**MOUNT POLLEY MINING CORPORATION
MOUNT POLLEY MINE
TAILINGS STORAGE FACILITY**

**ADDENDUM TO REPORT ON CYCLONED
SAND CONSTRUCTION OF STAGE 3
AND ON-GOING STAGES OF THE TAILINGS
STORAGE FACILITY
(REF. NO. 11162/13-4)**

RE: Stage 3 Addendum Report

SECTION 3.0 - RESPONSE TO AGENCY COMMENTS

FIGURE 3.2

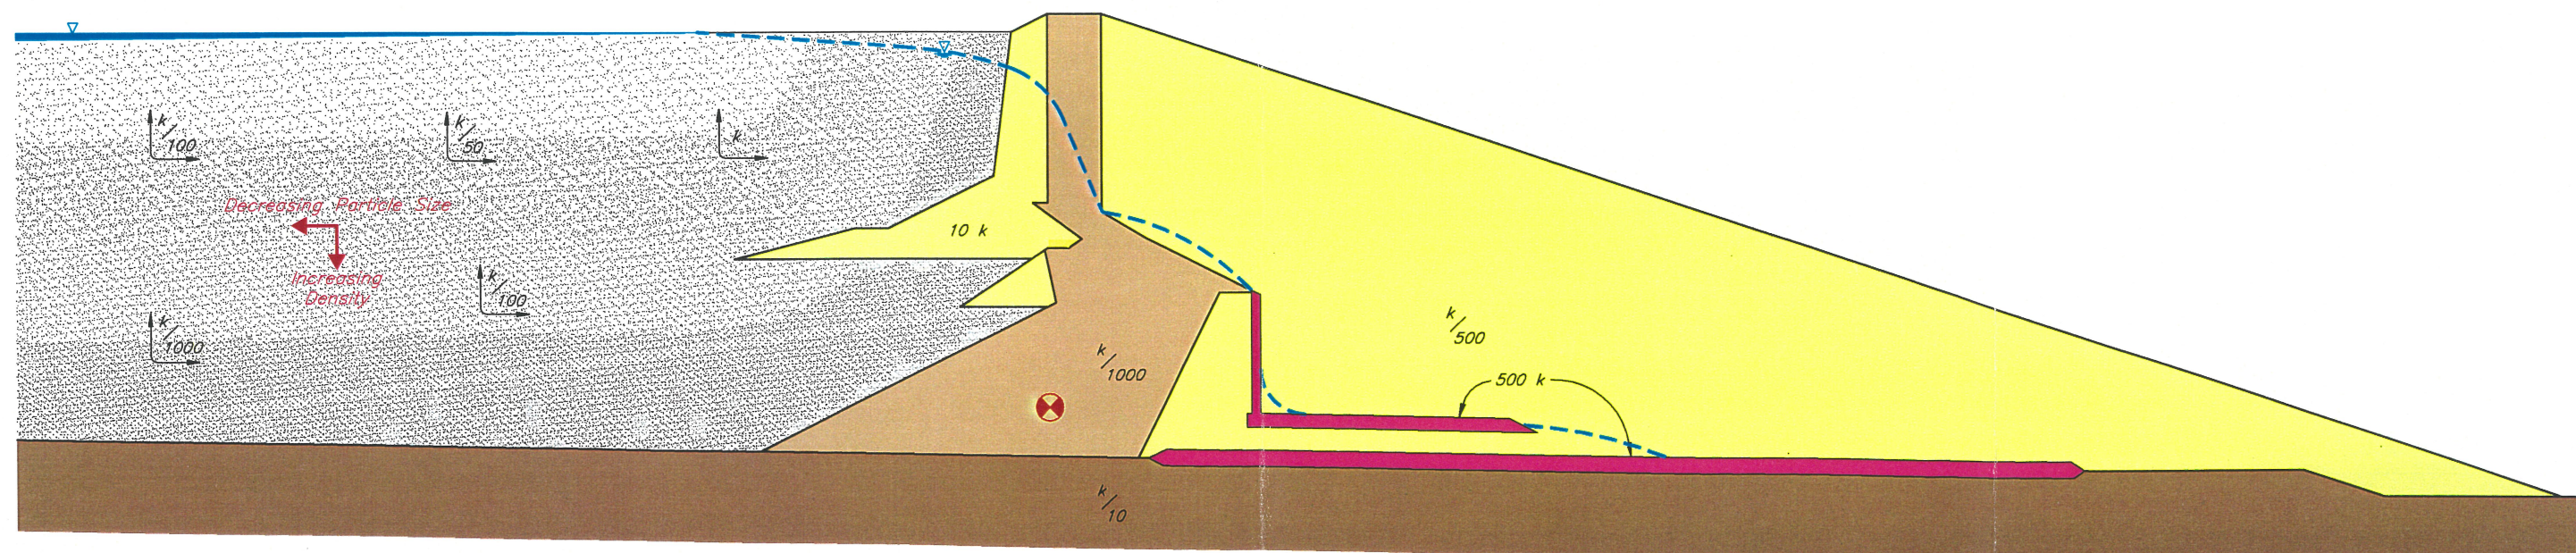
water-retaining dam. Specifically, the drains act to depress the phreatic surface within the tailings storage facility, thereby reducing overall seepage gradients through the embankment core zones, and convey seepage waters directly to the seepage collection and recycle facilities and minimize the opportunity for losses to the environment via any previously-undetected permeable foundation layers. The effects of inclusion or exclusion of the toe drain on the phreatic surface of the embankment are shown schematically in the generalized sections of Figure 3.2.

FIGURE 3.3

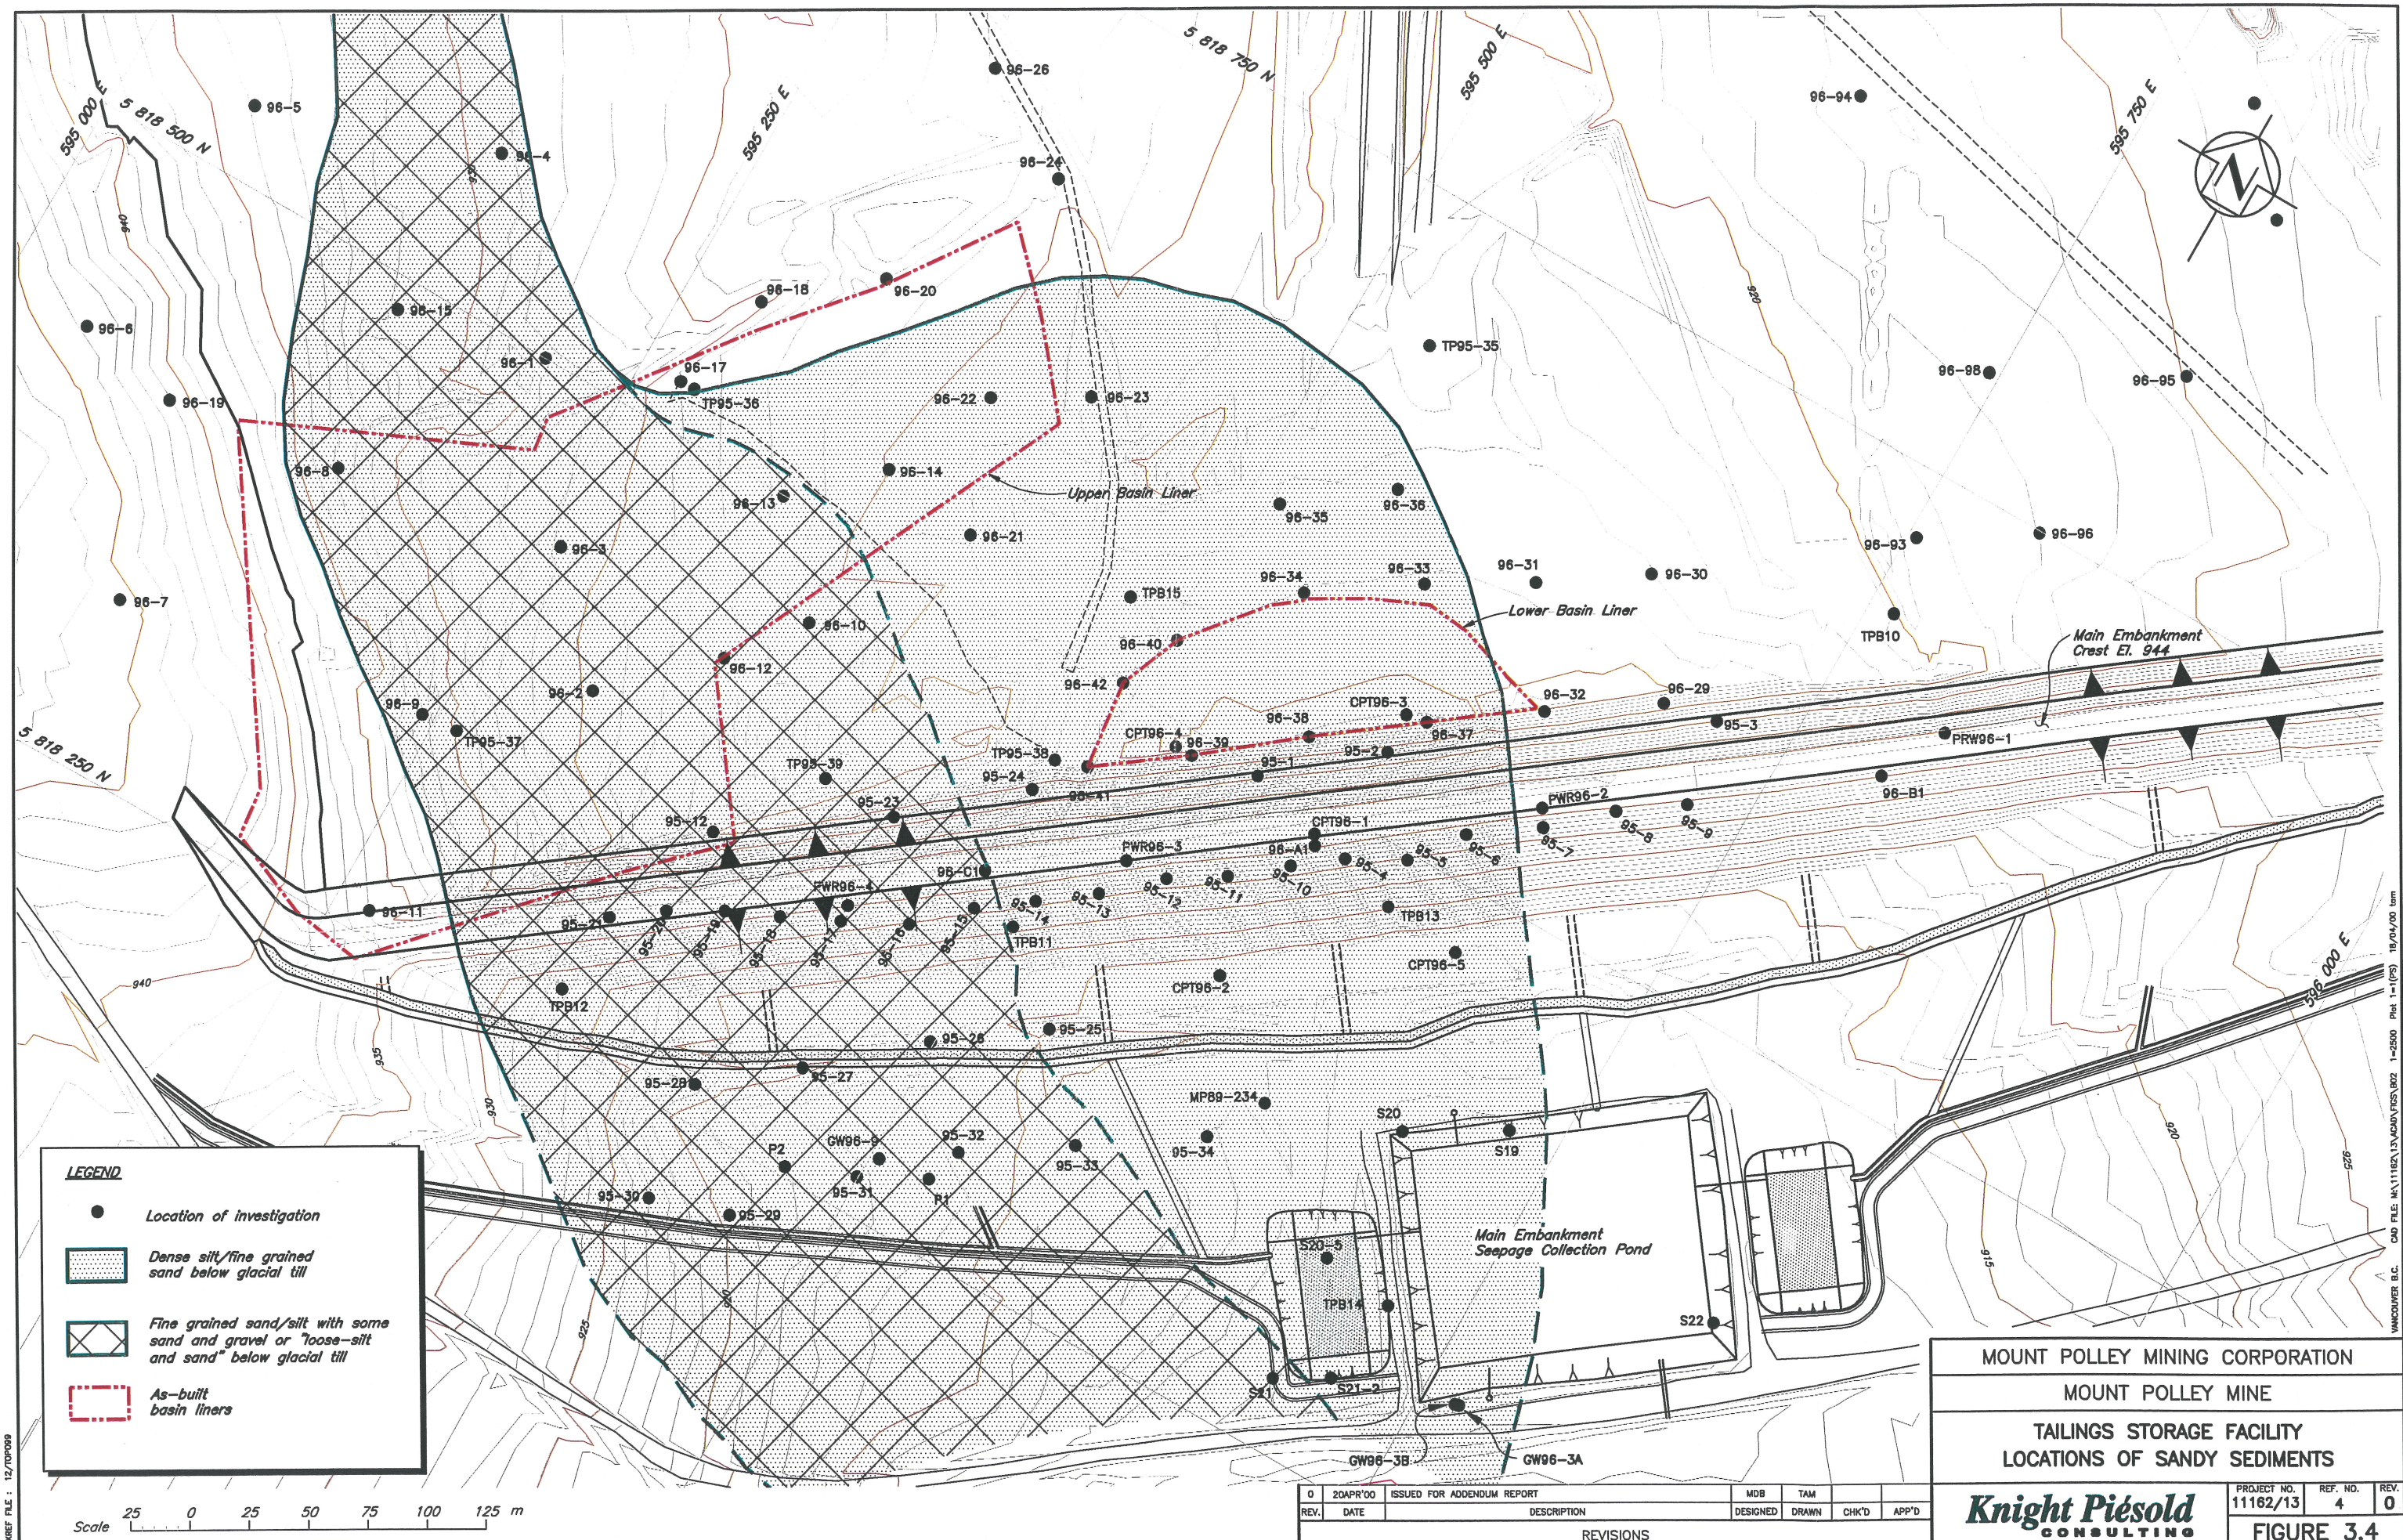
The use of the centreline method was successfully used at Gibraltar and Brenda Mines. It is recognized that the gradation of Mt. Polley is finer, therefore it is recommended that Knight Piésold – Mt. Polley Mines provide some further information such as:

these operating mines are summarized on Figure 3.3, which also includes additional information from the Similco and Gibraltar mines in British Columbia. The gradation of the Mount Polley cycloned sand underflow is also included on this figure for comparison. This information demonstrates that the Mount Polley cycloned sand underflow product represents an average gradation when compared to these mines (the gradation plots in the middle of the distributions from the other mines). It should be noted that the data for the MPMC underflow product was obtained during the trial programs and it is felt that a full-scale, optimized cycloning system will produce a cleaner (more free draining) underflow product as previously discussed.

MOUNT POLLEY MINING CORPORATION		
MOUNT POLLEY MINE		
TAILINGS STORAGE FACILITY		
STABILITY ANALYSIS		
DOWNSTREAM SHELL ZONE		
Knight Piésold CONSULTING	PROJECT NO. 11162/13	REF. NO. 4
	REV. 0	
FIGURE 3.6

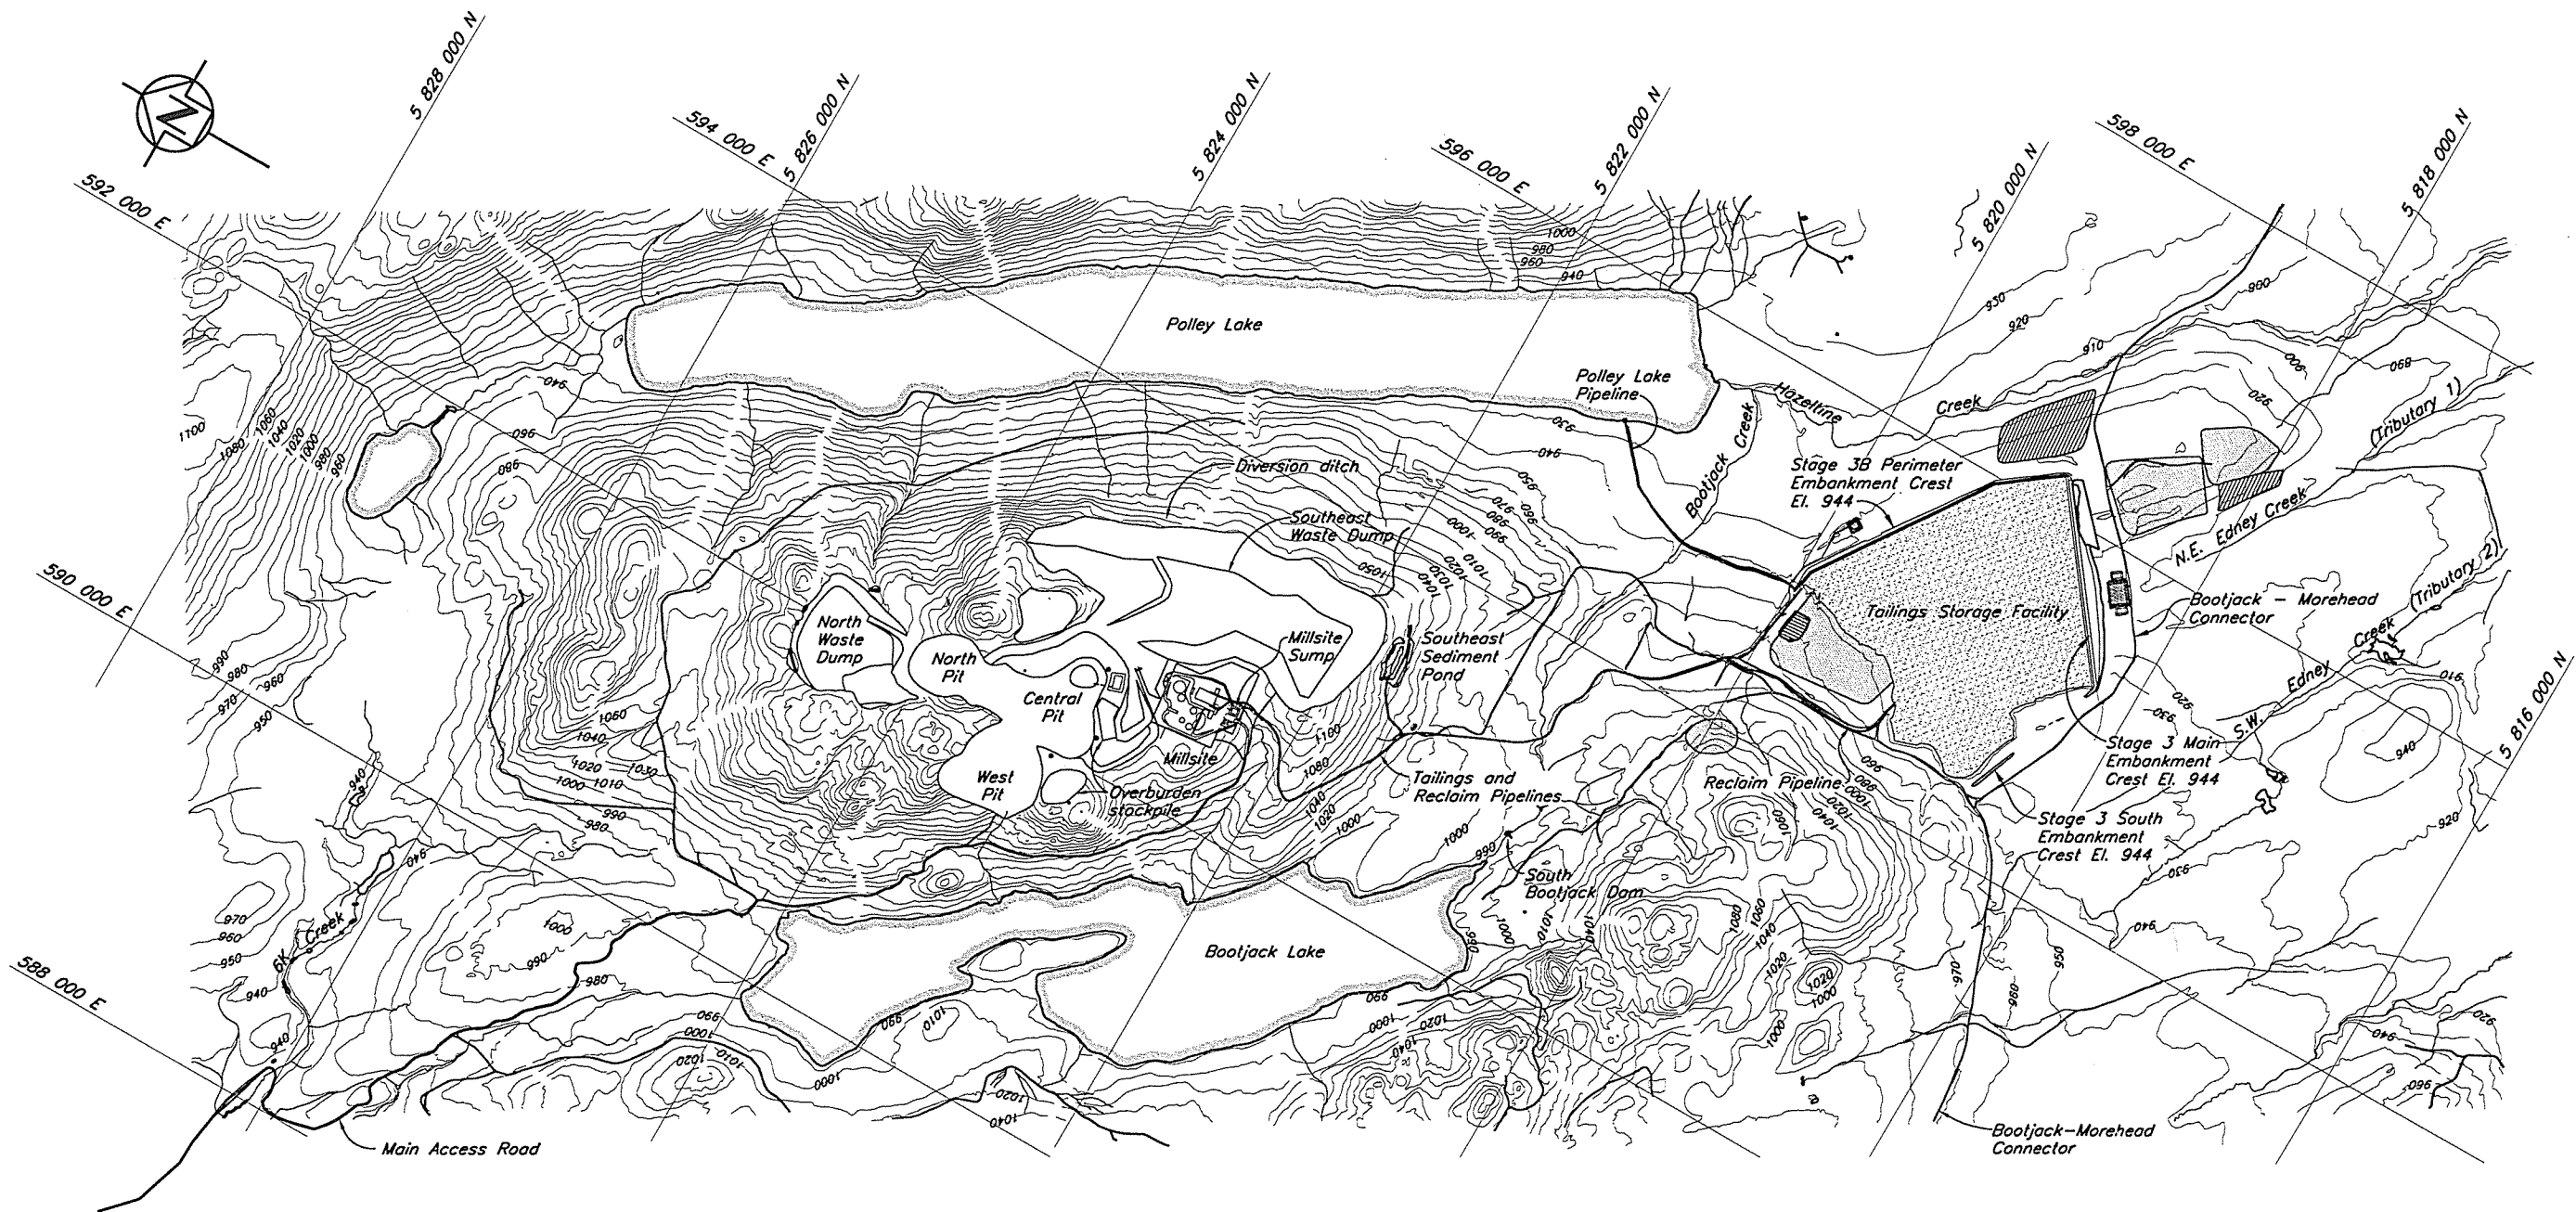
The temporary saturated condition will not occur during Stage 3 embankment construction, as only one hydraulically placed lift is planned. It is, however, a consideration for hydraulic placement in future stages of the embankment, and during deposition of underflow sand in Stockpile A. Therefore, an analysis of the

The stability analysis indicates an acceptable FOS against sloughing of the cycloned sand during hydraulic placement, and against deep-seated circular failure for on-going stages. The embankment and drain systems will be monitored and reviewed on an on-going basis to verify that the embankment is performing within the design tolerances.

The results of the analyses are summarized on Figure 3.6.
